# City of Mississauga

### City Department and Agency Comments

Date Finalized: 2024-11-13	File(s): A518.24 Ward: 2
To: Committee of Adjustment	
From: Committee of Adjustment Coordinator	Meeting date:11/21/2024 1:00:00 PM

**Property Address: 780 Parkland Ave**

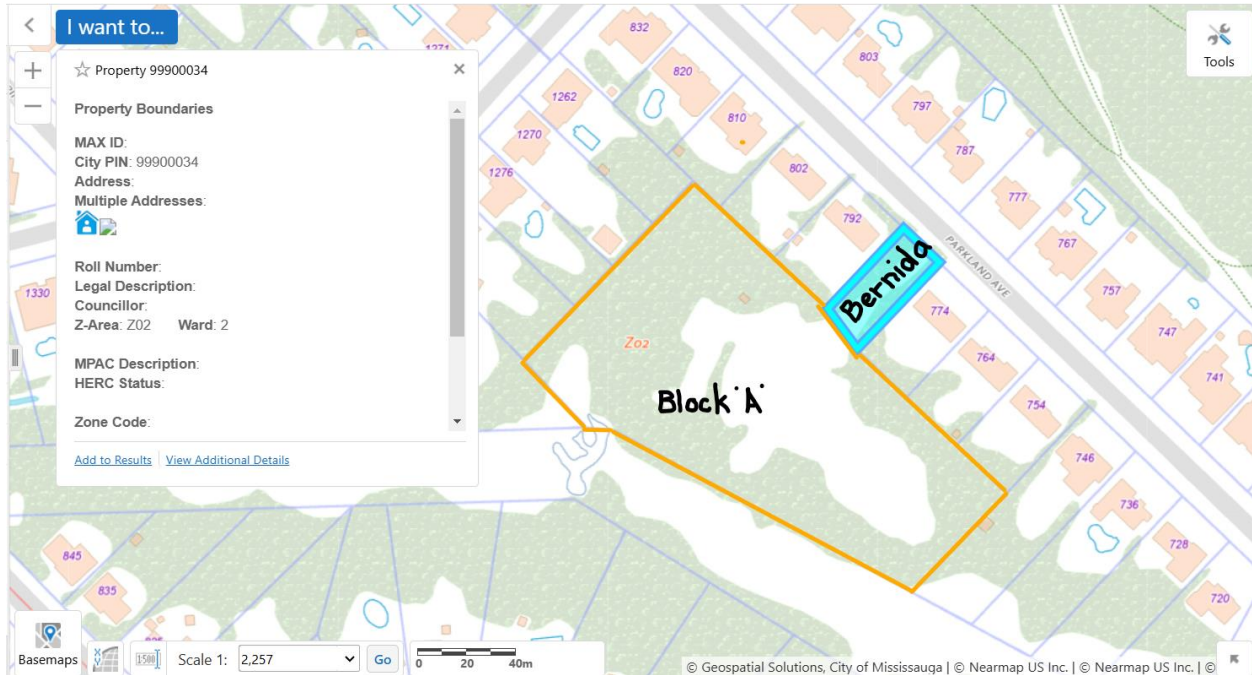
The lands are situated inset on the west side of Parkland Avenue, known as Block 'A', RP-417 (see attached). The applicant had approached The City earlier this year for an IZR (Independent Zoning Review) for a single family dwelling. At that time, there was no legal address for the property and an application could not be submitted. After many discussions with the applicant, it was decided that the lands be given a "temporary address" (780 Parkland Avenue) to facilitate the IZR review, however it should be noted that even with this temporary address the lands do not have direct physical access from property to the Parkland Avenue right of way. The City currently owns the subdividing parcel known as/ referred to as Bernida Road. It is a dedicated undeveloped right of way conveyed as part of a Plan of Subdivision in the 1950's through the registration of R.P. 417. For the property owner to reach Parkland Avenue they must first cross Bernida Road (please see attached R. Plan).

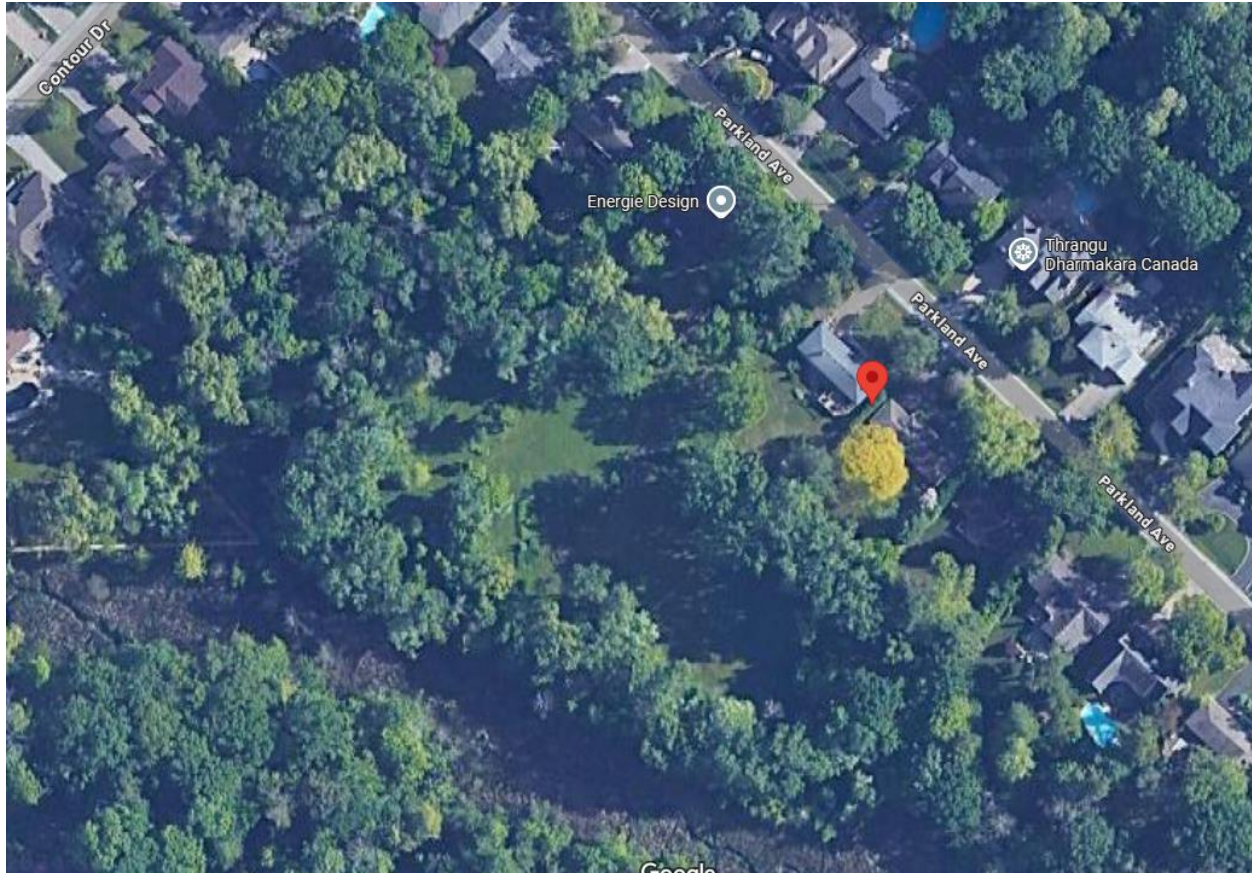
In addition to the variances reviewed herein, the City also currently has an Encroachment Agreement applied for by the applicant for access and servicing through the Bernida Road lands. This Department has provided separate comments not in support of the Encroachment Agreement. The recommendation for deferral will afford the time necessary to further coordinate internally and with the applicant to better outline and ensure proper servicing and access options available.

In consideration of the above, this department recommends the deferral of any variance approvals for the lands applied for under the temporary 780 Parkland Avenue address until such

time as the owner has made satisfactory arrangements with the City regarding resolution to providing access and servicing of the subject lands.
